**PLANNING & ZONING COMMISSION MEETING
HUXLEY CITY HALL COUNCIL CHAMBERS**

Ankeny Lawn & Landscaping Site Plan

HUXLEY, IOWA
ANKENY LAWN CARE
BLUE SKY COMMONS PLAT 2 LOT 2
SITE PLAN REVIEW

We have reviewed the site plan for Ankeny Lawn Care and offer the following comment:

SHEET NUMBER:
C3.1

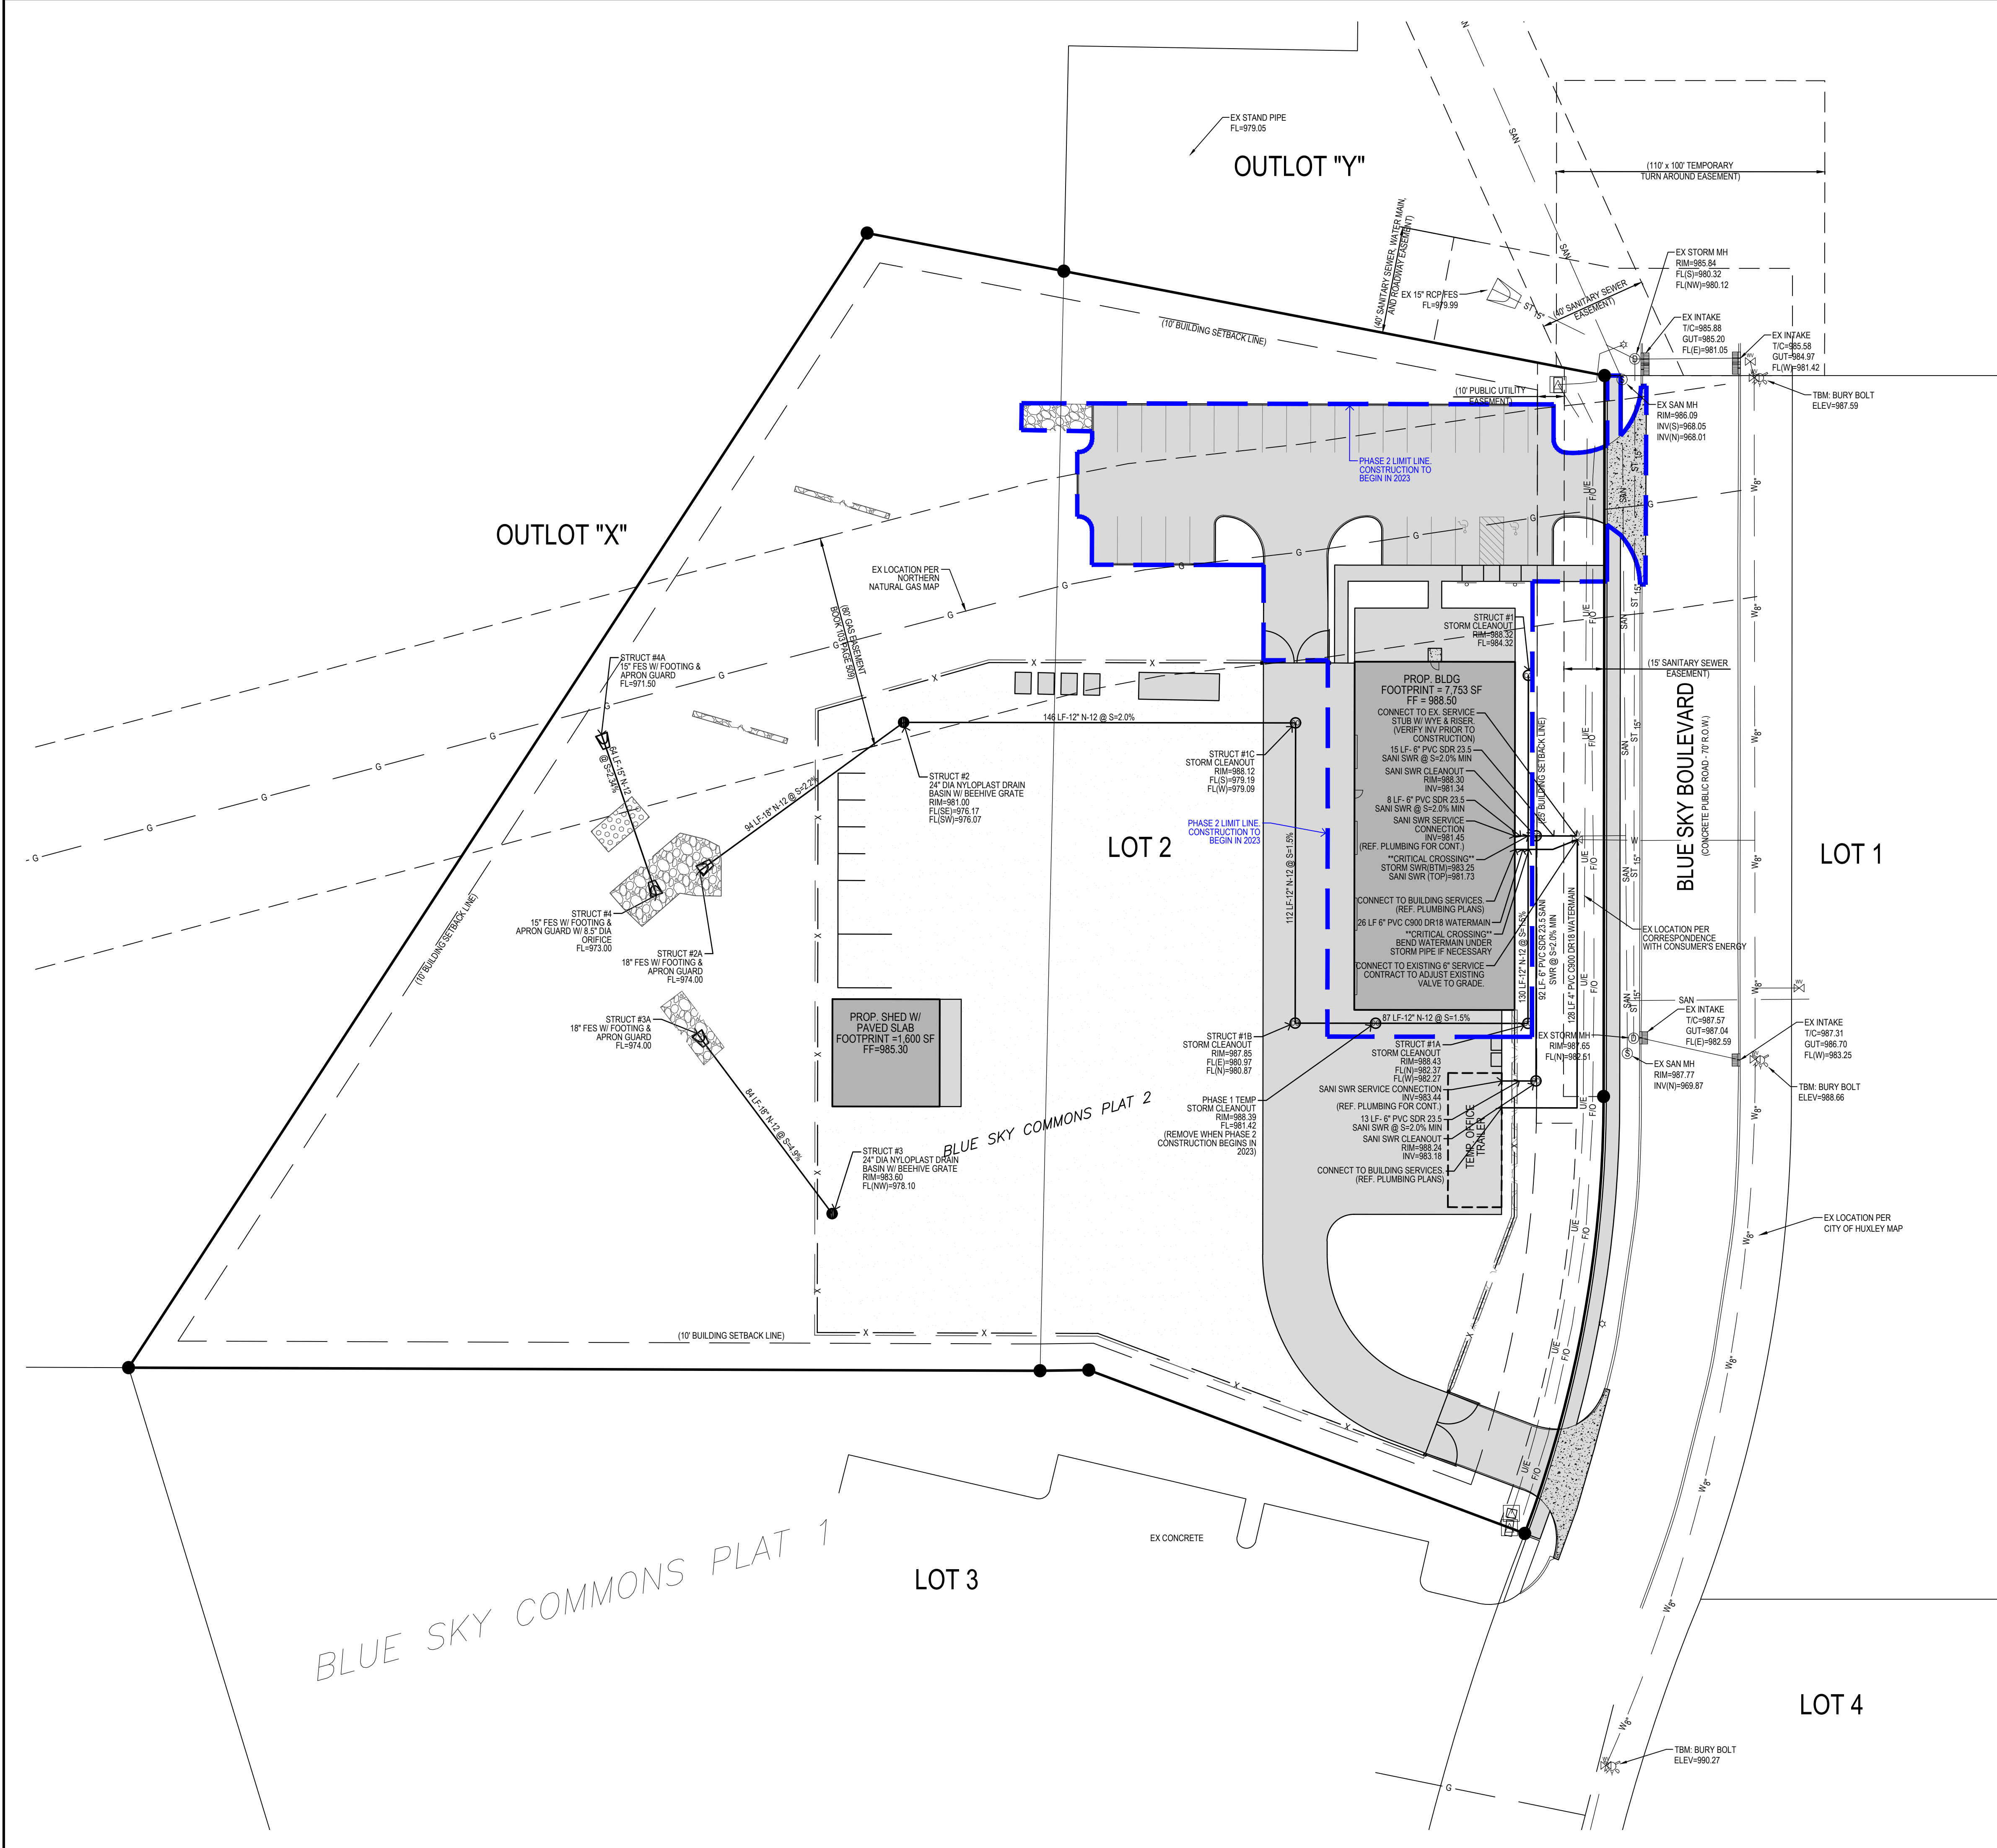
14. Sidewalks through driveways need to be a minimum of 7-inches thick.
15. Show the detention basin emergency overflow weir location and elevations on Sheet C3.1.

REFERENCE NUMBER:
DRAWN BY: GSA
CHECKED BY: SVS
REVISION DATE: 1st City Sub 2022-05-02 2nd City Sub 2022-06-06
PROJECT NUMBER: 210346
SHEET NUMBER: C4.1

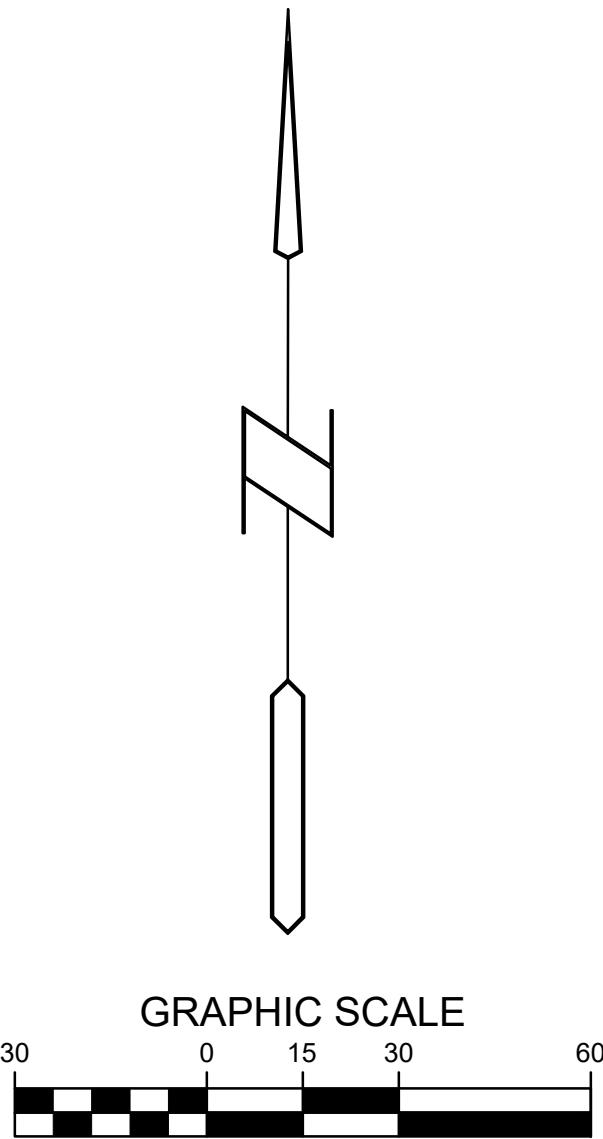
1. Provide information on the materials to be used for the water service. Water services 2" or small are to be copper. Water services larger than 2" are to be pvc C900 DR18 or ductile iron.
2. Install tracer wire on the water service. Terminate in flush mounted tracer wire box Drainage & Water Solutions Figure No. TWAB. Use 3M Scotchplast Splice Encapsulation Kit 3832 for all tracer wire connections.
3. Connections to the existing water service with a tapping sleeve and valve is not necessary. The City can isolate the water main if needed.
4. If the building will be sprinkled, we recommend the water service remain 6-inch into the building instead of being reduced to a 4-inch service.
5. Label contacts for inspections and utilities as follows:

9. Provide inlet protection to the existing intake located on the west side of Blue Sky Boulevard at the north end of the site.
10. Pipe materials to be pvc SDR 23.5 for 6-inch services and pvc truss pipe for services 8-inch and larger. Minimum size is 6-inch. Change the 4-inch service shown to 6-inch.
